MIKE CAUSEY, INSURANCE COMMISSIONER & STATE FIRE MARSHAL  
BRIAN TAYLOR, CHIEF STATE FIRE MARSHAL

September 1, 2021

**RE: Dwelling Separation Requirements Related to Single Means of Egress  
2018 NCBC 420 and 1006.3**

100  
Housing Studio - CHARLOTTE, NC.  
07/13/21

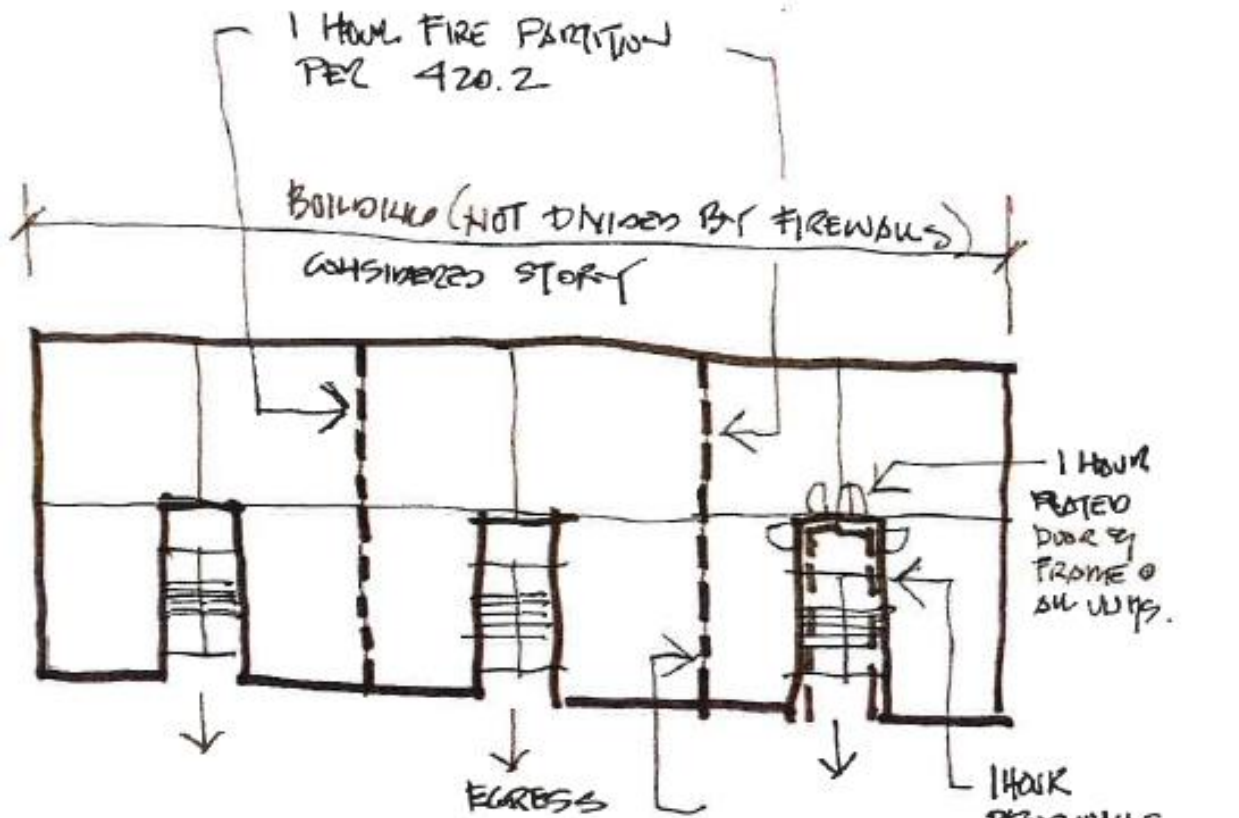
For a configuration, as submitted in "Exhibit 'B' of Attachment A below, does the use of Table 1006.3.2(1) allow all the dwelling units to be separated as allowed by Section 420.2 or are firewalls complying with Section 706 required between the pods?

Exhibit 'B' of Attachment A shows 3 sets of 4 dwelling units. This interpretation assumes these dwellings to be on a level other than the level of exit discharge with a maximum of 4 dwellings egressing to a single exit. The story, however, has 3 means of egress.

*Comment: The footnote indicates that the table applies to Group R-2 occupancies that consist of dwelling units. The table, therefore, applies to the situation shown in Exhibit 'B' of Attachment A below.*

See Attached. Still questioning the requirement or firewall between groups of four R-2 units and single egress stair.

We would consider the attached layout as a single building, including four R-2 units, each with its own egress stair and separated by a minimum 1 hour fire partition between each group of 4 units and stair. If the plan layout as shown does not contain a firewall then the 3 sets of units would be considered as 1 building, and if this building meets the requirements of area and height tables in Chapter 5 we interpret this layout as one building.

Table 1006.3.2(1) is not intending to limit application to buildings where only 4 dwellings units exist per story per building but intends to limit 4 dwellings units on a story to a single exit. The 2015 IBC Commentary shown in Exhibit 'F' of Attachment A below supports this conclusion. The result is that you can have multiple pods with single exit per pod on a story separated with fire partitions as required by Section 420.2 instead of fire walls complying with Section 706.

Your attached sketch can be code compliant without construction of Section 706 fire walls. As long as the allowed building area is met for the construction type fire walls are not required; the 4 unit pods can be separated as required by Section 420.2 & 708.1.
